No. HDCM17-089-TN

Technical News

Subject: Software Release [AT Software: V3.30]

1. By setting HDR MODE to LIVE HDR in CCU MENU S10<4K/HDR>, HDR-related adjustment items can be adjusted.

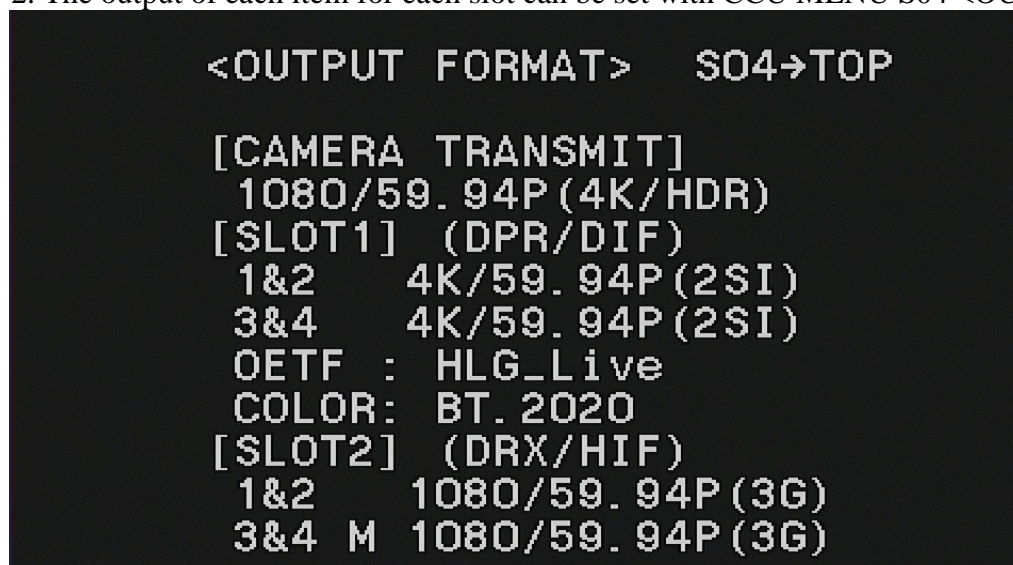
HDR MODE: Sets the HDR mode.

LIVE HDR: Expands the imaging dynamic range on the camera side, and outputs the adjusted HDR video.

SDR GAIN: Sets the gain for the SDR output (valid only for LIVE HDR).

HDR CONTRAST: Displays the contrast of the HDR output secured by setting SDR GAIN (valid only for LIVE HDR).

BLACK OFFSET: Black offset for the HDR output (valid only for LIVE HDR).

2. Select the output in CCU MENU S04 <OUTPUT FORMAT>.

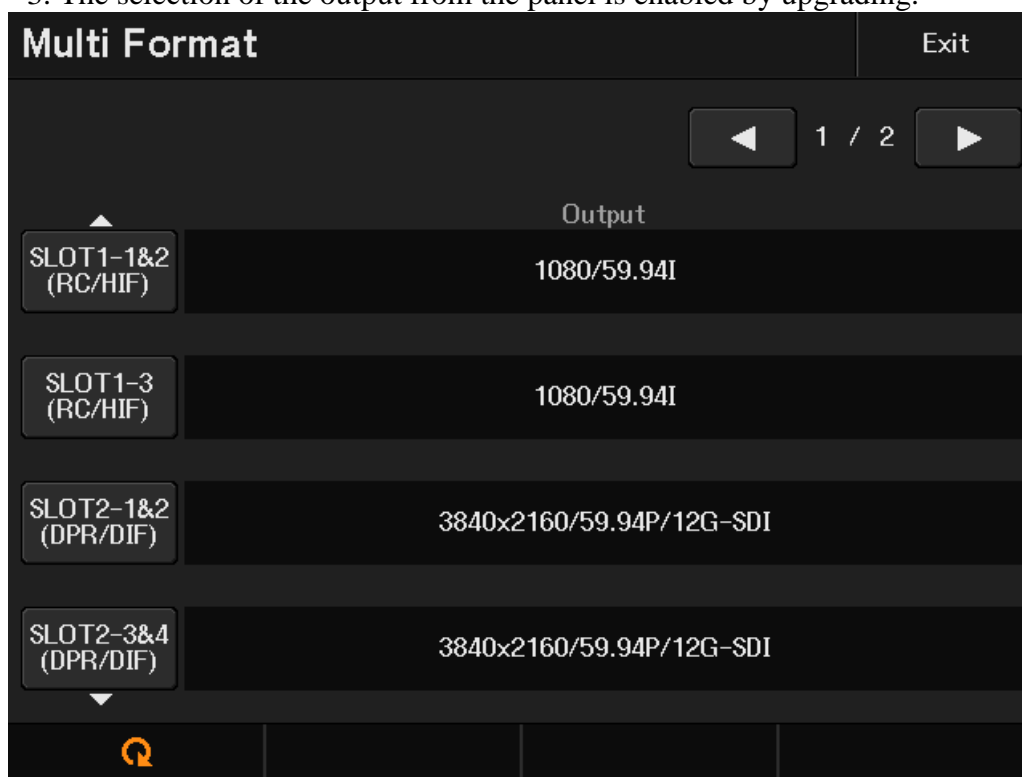
[Setting of 12G-SDI Output]

1. Set "CAMERA TRANSMIT" to "1080P(4K/HDR)".

The selection of 12G-SDI output is enabled with the slot which the HKCU2040 is installed by setting CAMERA TRANSMIT to 1080P(4K/HDR).
